Overview: Production error in version 1.0 harnesses; The immobilizer wire (orange/black) is in pin position #4 instead of pin position #5. Although an effort to correct the issue was made, some quantity of harnesses did get shipped before the issue was spotted. We are advising to inspect the harness BLADE connector before attempting to install harness or program the module. This issue is not known to affect the version 2 harnesses, which require no modification.

FTI-STP1: Notas de instalación y configuración

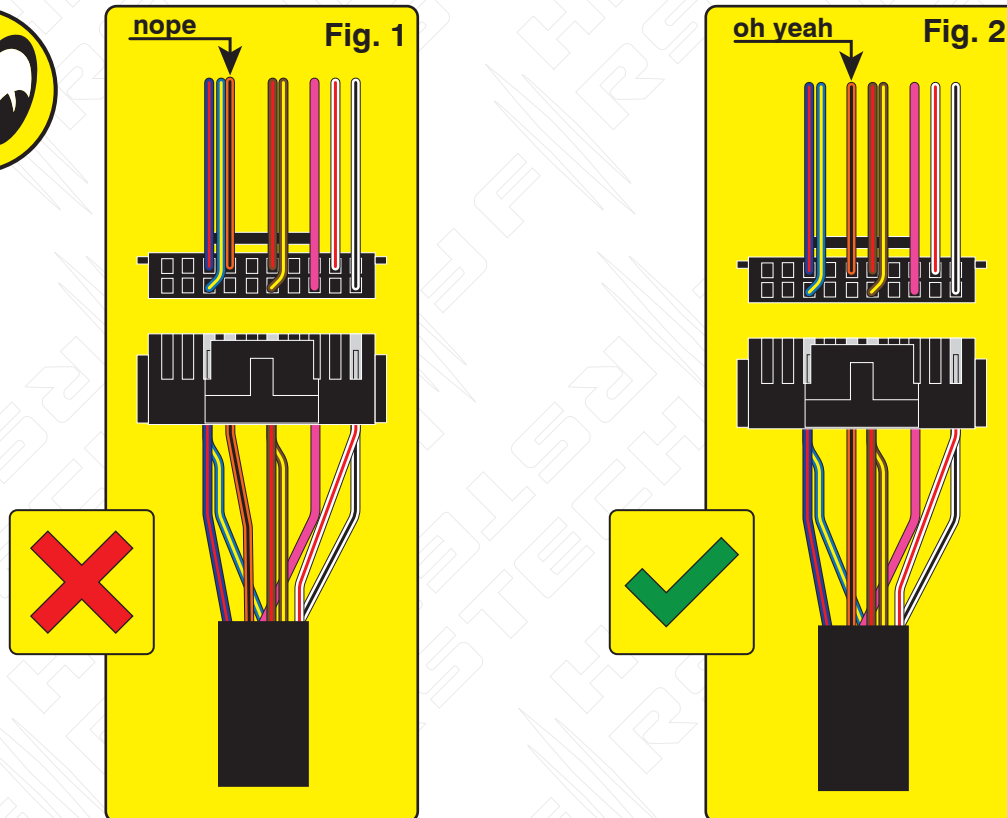
Issue: Module fails to program correctly to vehicle, does not allow the vehicle to be remote started.

Correction: Step 1.) Locate the orange/black wire and confirm whether it is positioned as illustrated in Fig. 1 or Fig. 2. If the wire is as illustrated in Fig.1, proceed with Step 2 through 5 and complete the repair procedure outlined, if the wire is as illustrated in Fig. 2, correction is not necessary, proceed with harness installation and module programming.

Step 2.) Using a pick, lightly depress the catch that secures the terminal in the housing then remove the wire and terminal from the housing.

Step 3.) Using a fine tip razor or utility knife, insert the blade beneath the terminal catch and raise it slightly, so that it can be reused to secure the terminal when reinserted into the BLADE connector housing.

Step 4.) Refer to Fig. 2 for correct position of the orange/black wire (next to brown/red) then reinsert the terminal, pressing lightly until the catch 'snaps' into place, securing the terminal in the connector housing.

MODIFICACIÓN REQUERIDA PARA APLICACIONES A/T, SÓLO CON ARNÉS v 1.0

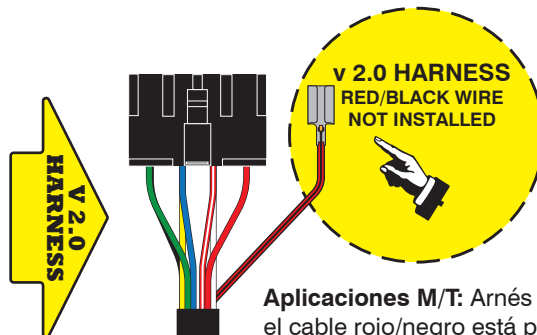
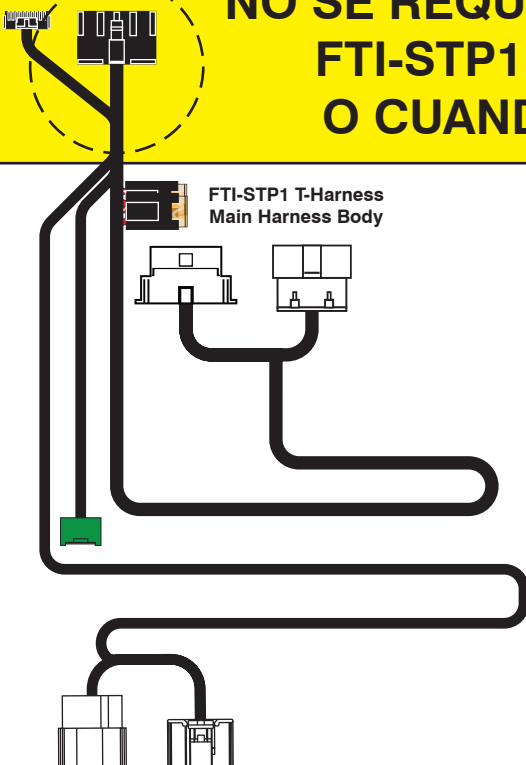
Problema: El arnés en T FTI-STP1 ha sido diseñado para ser compatible con A/T (transmisión automática) y M/T (manual), pero debido a un descuido en las primeras ejecuciones de producción, la selección se estableció por defecto en el modo M/T.

El uso de un arnés configurado para una aplicación M/T, en un vehículo equipado con A/T, podría provocar daños en el módulo del vehículo, se recomienda que el arnés vuelva al modo A/T antes de la instalación en vehículos equipados con transmisión automática.

Corrección: Localice el cable rojo/negro (+ embrague) proporcionado en el conector CN1 del conjunto del arnés principal. Corte el cable rojo/negro, ya sea al ras del conector CN1 o dejando suficiente cable expuesto para que pueda aislar y asegure los extremos del cable que quedan después del corte. Aísle cada uno de los extremos restantes del cable rojo/negro y asegúrelos para evitar cualquier posibilidad de cortocircuito. Si el cable rojo/negro ya ha sido desconectado, ninguna modificación adicional se requiere para aplicaciones A/T
